**From:** [S Mason](#)  
**To:** [Rebecca Noecker](#)  
**Cc:** [Spencer Miller-Johnson](#); [\\*CI-StPaul Contact-Council](#)  
**Subject:** Public Comment in Opposition to Proposed EGAOD changes. Add a rear setback and step back to the EGAOD.  
**Date:** Friday, July 19, 2024 1:06:09 PM  
**Attachments:** [1- ANNOTATED Parritz public comment presentation.pdf](#)  
[2-ANNOTATED Parritz public comment presentation.pdf](#)  
[3-ANNOTATED Parritz public comment presentation.pdf](#)  
[4-comments.pdf](#)  
[5-Comments.pdf](#)

**ANNOTATIONS TO PUBLIC COMMENT IMAGES**

695 Grand Ave: Massing as constructed

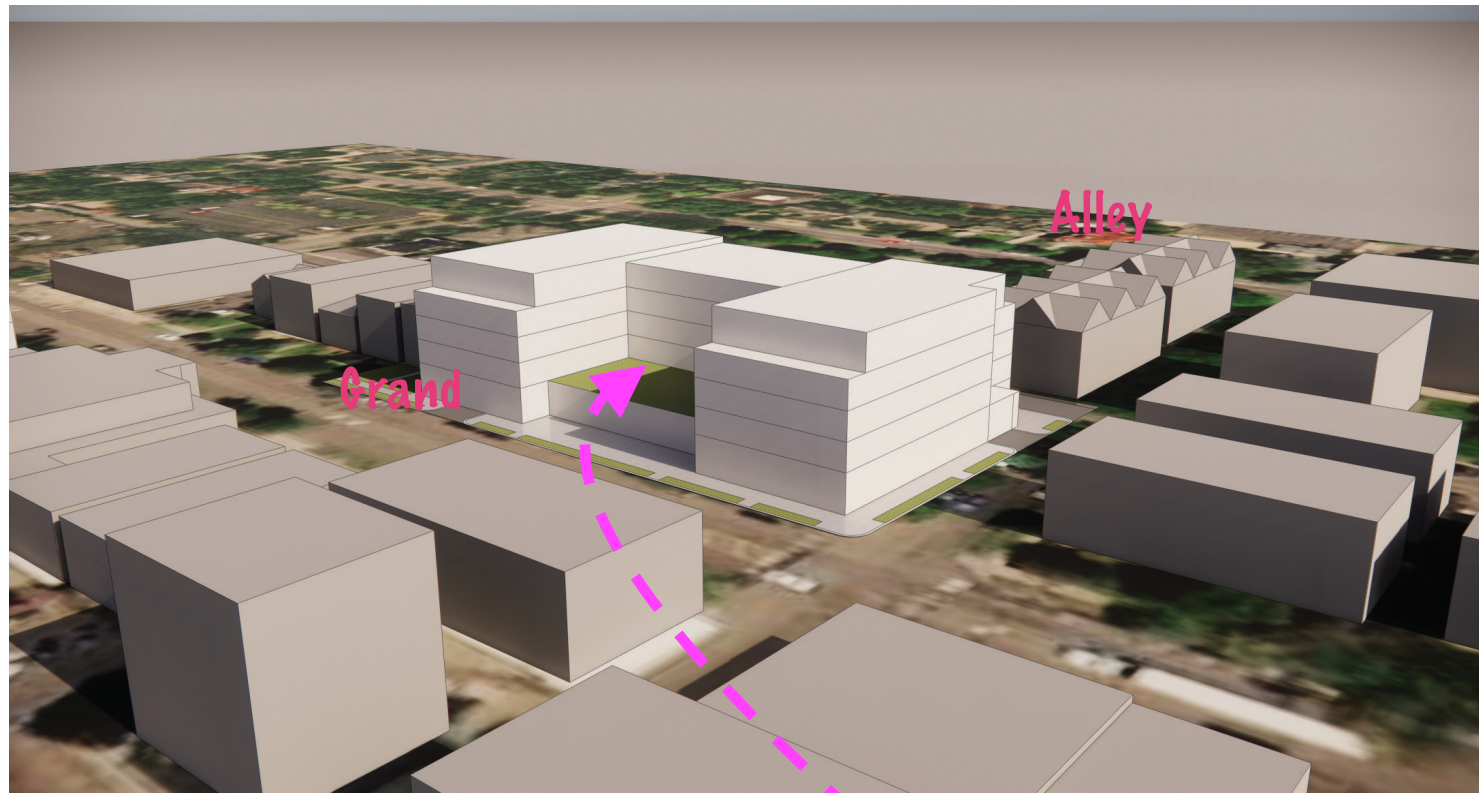
**The green area in the center is buildable.**

695 Grand Ave: Massing as restricted by proposed amendments

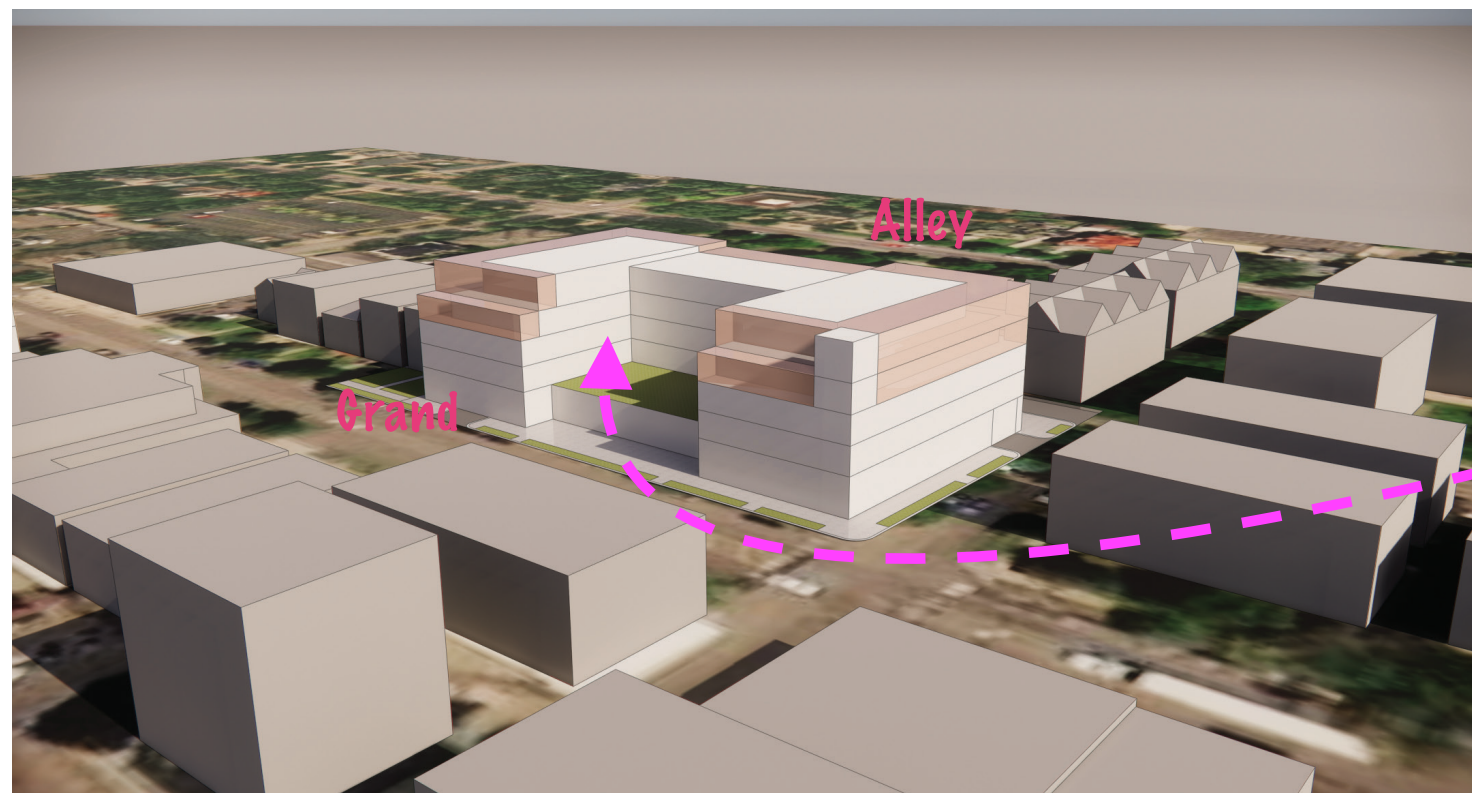
**1 Why, in all of these, is there LESS bulk and building mass facing Grand?**

**And MORE bulk close the neighbors?**

**Why is there a giant area on Grand that could be built, but wasn't?**

695 Grand Ave: Highlighted area of built project that would not be allowed under proposed restrictions

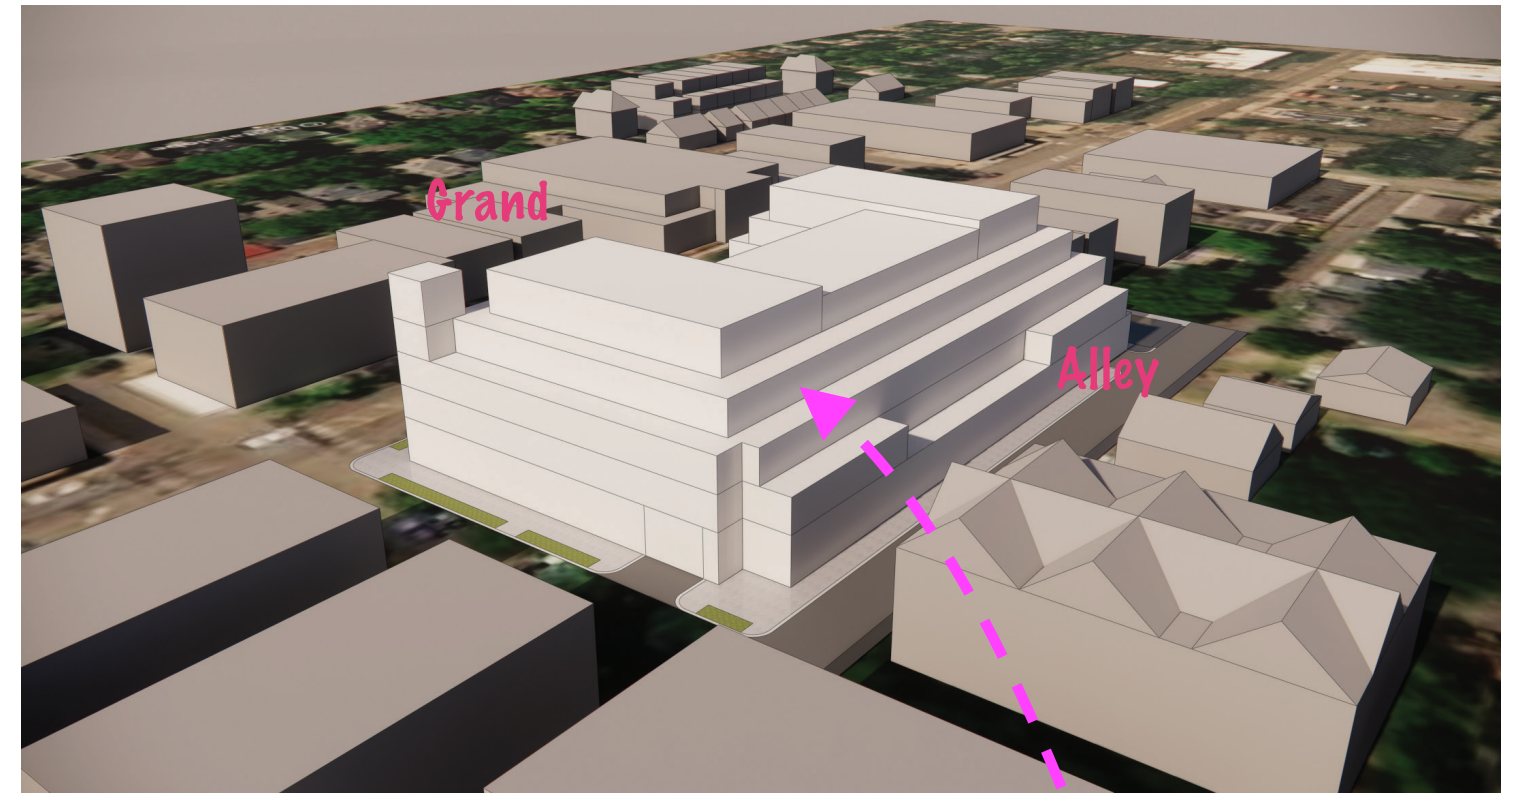
**Why is it NOT built?**

695 Grand: Massing as restricted by proposed amendments

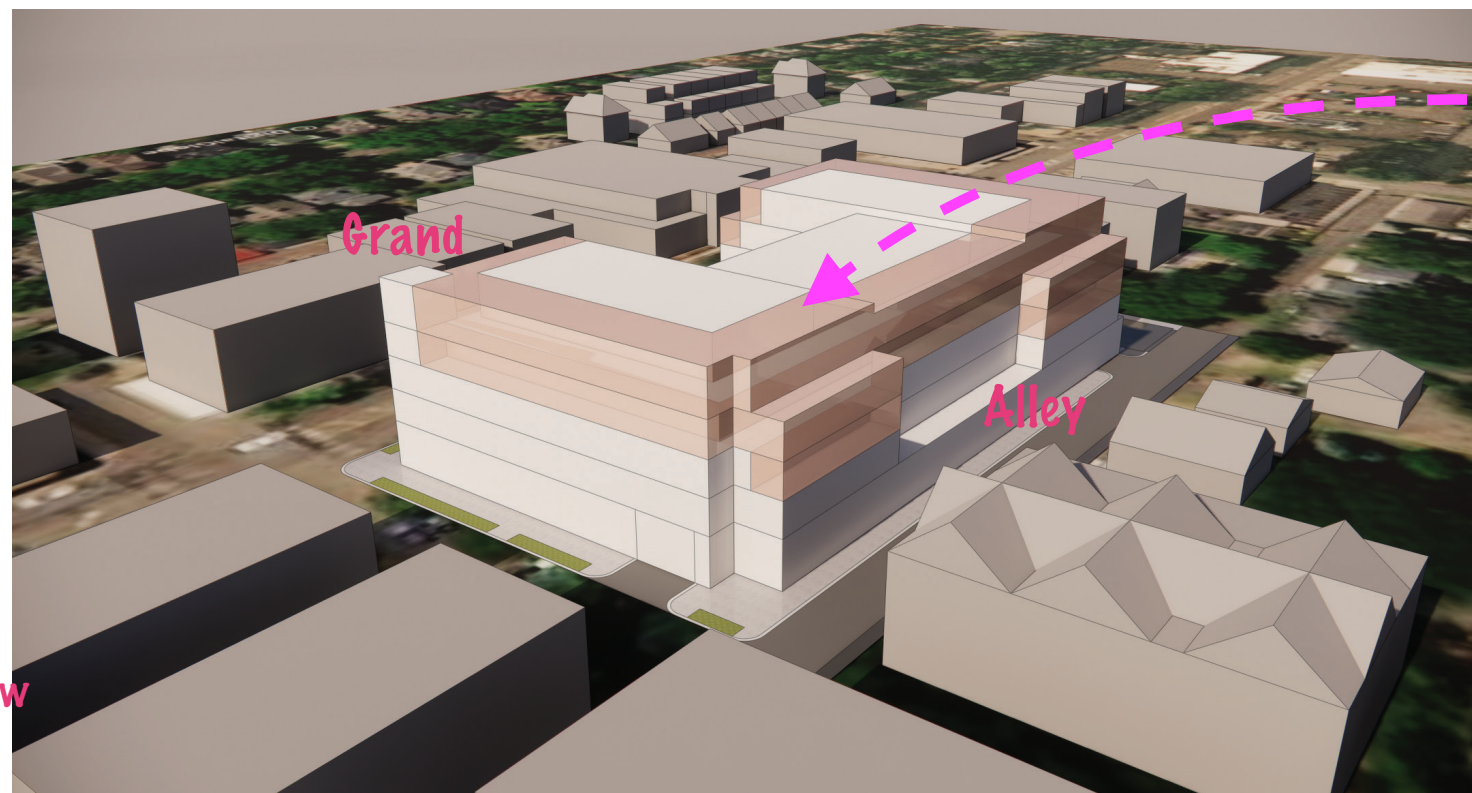
Imagine this flipped. Why is there more height and more massing at the rear, toward the residential neighborhood?

Residential neighbors near 695 Grand have been negatively impacted by the tall walls that were constructed:

- \* ice build up in the 6-month fully shadowed alley has impeded access & trash collection
- \* a 90 dBA piece of equipment installed in the narrow strip of land along the alley runs 24-7 in the summer, limiting neighbors ability to use outdoor spaces and have open windows.
- \* Litter (chiefly cigarette butts & dog poop) is a huge problem as the building has no outdoor space for employee smoking or dog relief.

This would be somewhat better.

Removing the highlighted areas would be an improvement for residential neighbors to the north. However, there is still too much building oriented toward low density.

Why is the building oriented away from Grand?

Since Grand needs development, then the building and its bulk, as well as its noise, deliveries and activity should all be oriented toward Grand

734 Grand Ave: Possible Massing

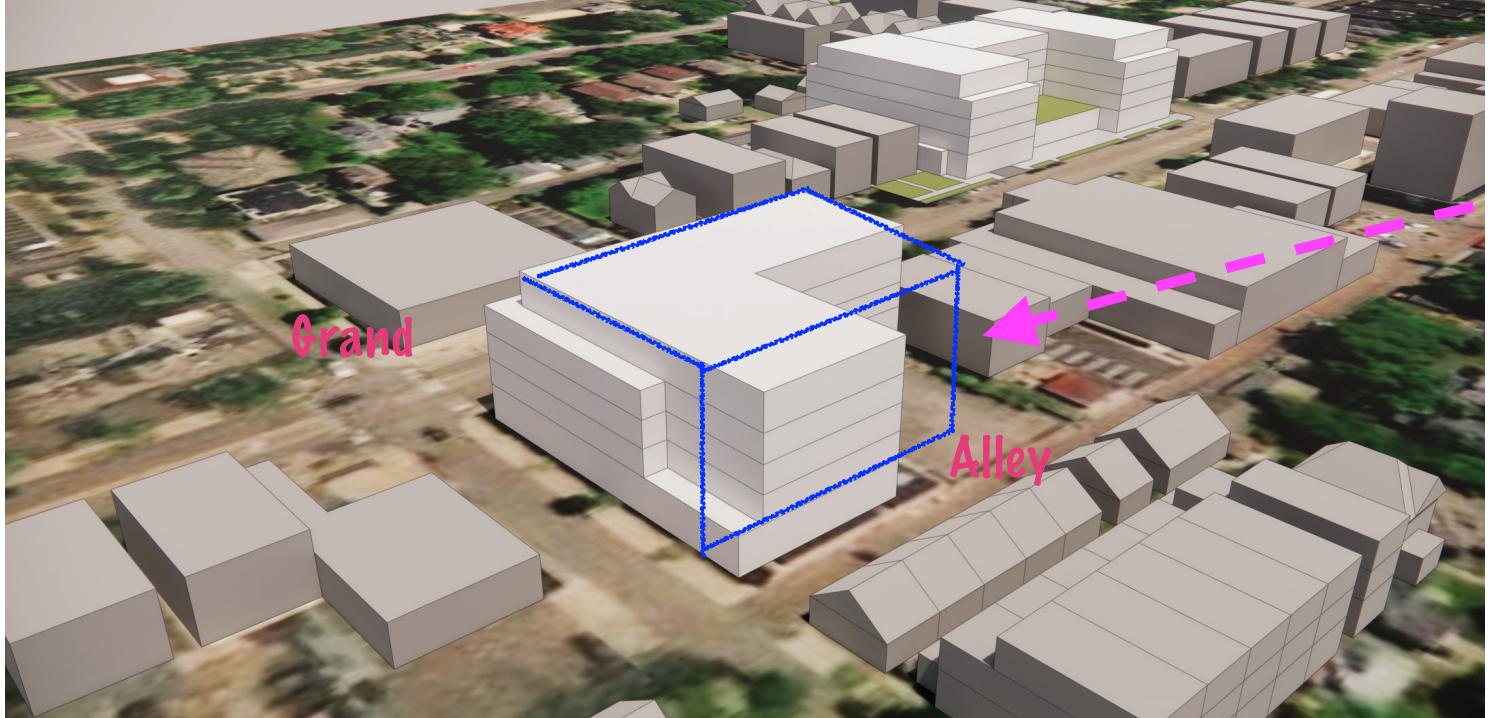
These "POSSIBLE MASSINGS" are better than what was built at 695 Grand. The lower images show better "transitions" to sensitive areas, to the housing & neighbors NOT on Grand

But why does the Tall Height and Large Bulk need to come all the way back to the alley? Why not provide a buffer space to protect the residents on Lincoln from the noise, loss of privacy, etc.

734 Grand

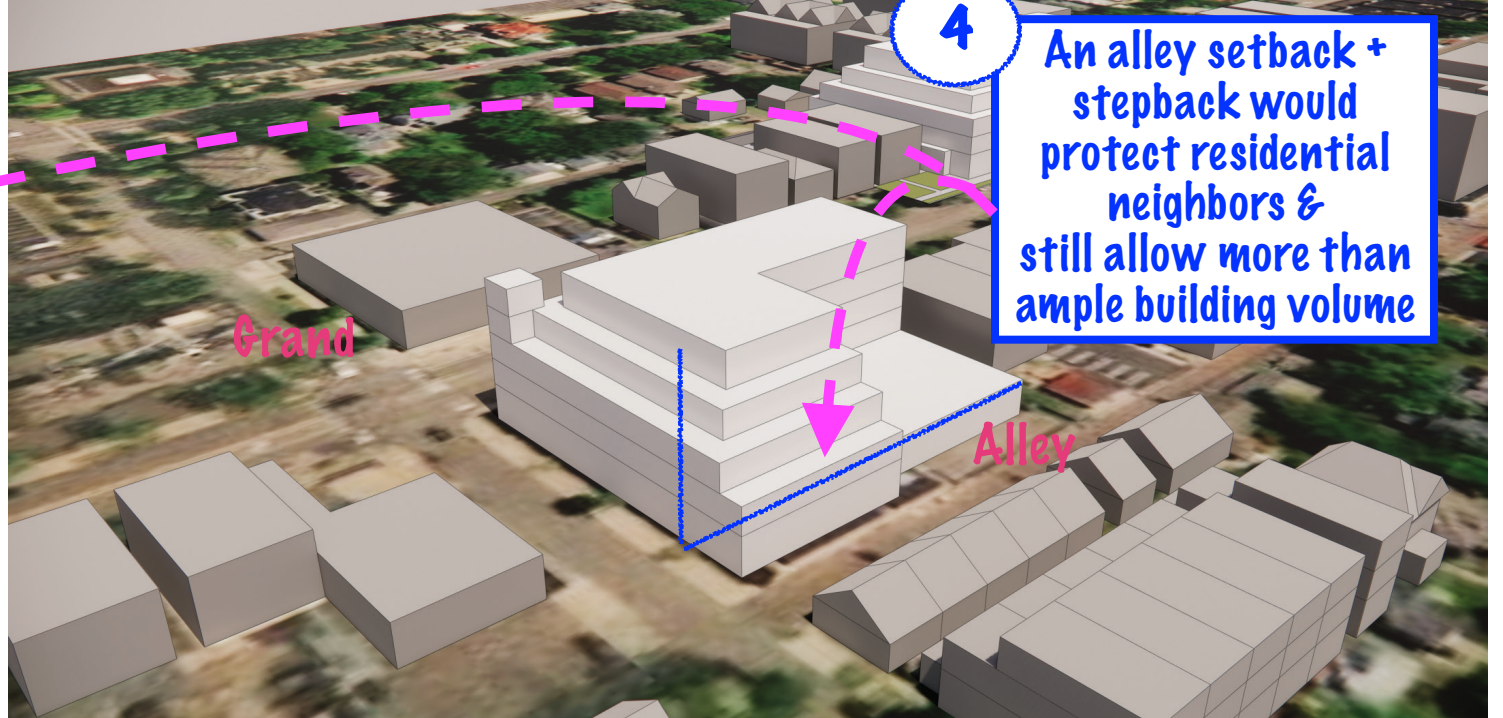
This is the Walgreens sight. They currently have a tall fence to protect the neighbors from noise etc. Parking comes from Grand. Deliveries happen from Grand & Grotto. The alley is a quiet buffer, This design puts all the noise, traffic and delivery pressure on the residential alley. There is no place for moving trucks and deliveries for the (presumed) 80+ luxury apartments. This layout would likely have noisy equipment installed right at the alley, close to neighbors. This design reduces privacy & provides no buffer.

The Overlay must provide protections for the neighbors on Lincoln, Summit, & side streets.

An alley setback + stepback would protect residential neighbors & still allow more than ample building volume
